GE Hitachi Nuclear Energy

MFN 08-481

Docket No. 52-010

Subject: Response to Portion of NRC Request for Additional Information Letter No. 178 Related to ESBWR Design Certification Application – Human Factors Engineering - RAI Numbers 18.7-7 S03, 18.7-8 S03, 18.8-2 S02, 18.11-21 S02, 18.11-25 S02, 18.11-32 S02, and 18.12-4 S03

Figure 4 HED Resolution Process

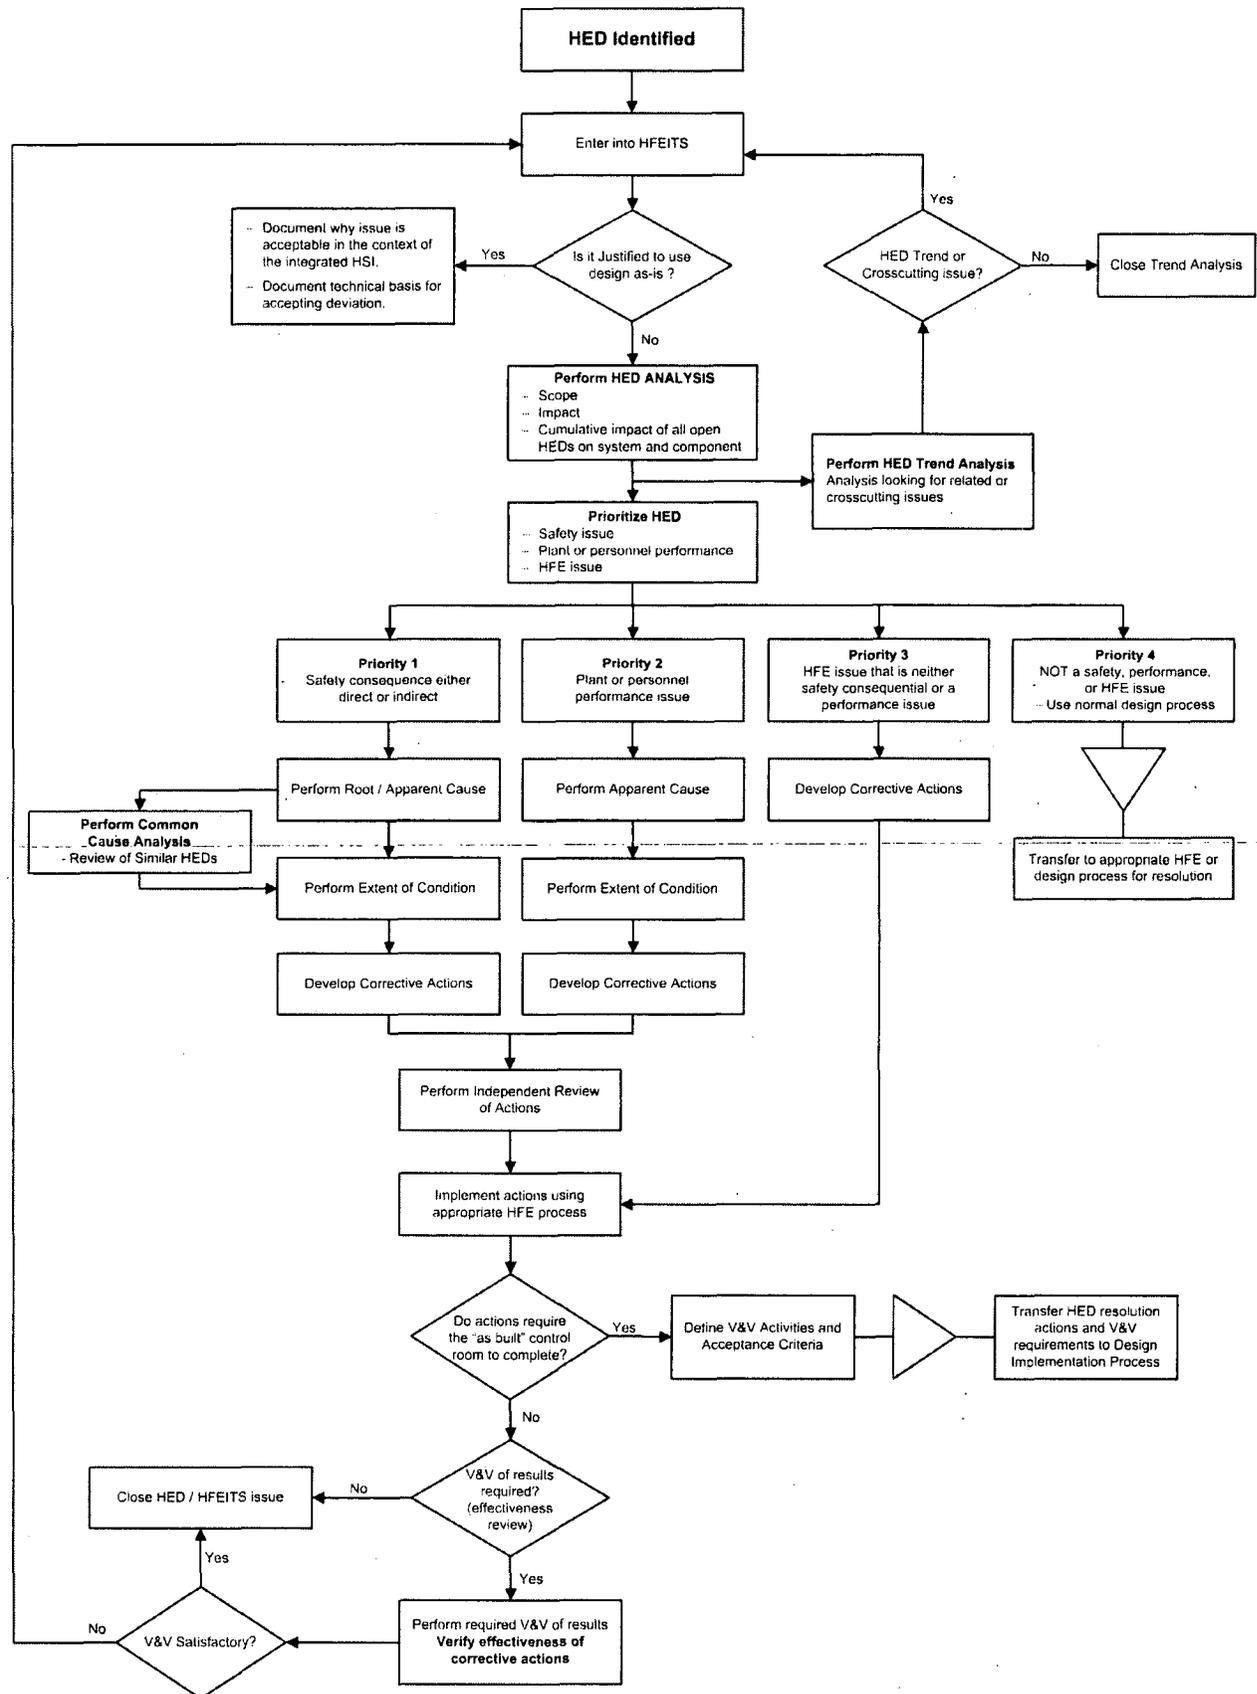
- Figure 4 begins with a decision block for "HED Valid?" What is the analyst evaluating at this point and how is the decision made. The write-up of the methodology is Section 4.6 begins with the second decision block "HFEITS Pri 1 or 2?" Thus no guidance is provided to the analyst.*

- Regarding the second decision block "HFEITS Pri 1 or 2?," how does the analyst make the decision whether the HED is Category 1 or 2? It appears the risk significance methodology results in a sorting of HEDs into four risk significance categories (see the bottom of Figure 4). If so, why is there a sorting at the top of the methodology?*

NRC: Figure 4 begins with a decision block for “HED Valid?” What is the analyst evaluating at this point and how is the decision made. The write-up of the methodology in Section 4.6 begins with the second decision block “HFEITS Pri 1 or 2?” Thus no guidance is provided to the analyst.

NRC: Regarding the second decision block “HFEITS Pri 1 or 2?,” how does the analyst make the decision whether the HED is Category 1 or 2? It appears the risk significance methodology results in a sorting of HEDs into four risk significance categories (see the bottom of Figure 4). If so, why is there a sorting at the top of the methodology?

GEH: A new Figure 4 was created that provides a means for resolution of all HEDs, those relating and not relating to style guide compliance. Thus, this concern is addressed by the new figure.

GEH: The concern regarding sorting at the top of the methodology in the previous version of Figure 4 is no longer applicable to the revised Figure 4, in which HEDs are prioritized and sorted only once.

GEH: A revision of Figure 4 and Section 6 provides a means for resolution of all types of HEDs, those that affect risk important human actions and those that do not. Thus, this concern is addressed by the revised Figure 4 and Section 6.

The major HED identification and resolution process steps, as shown in Figure 4, include:
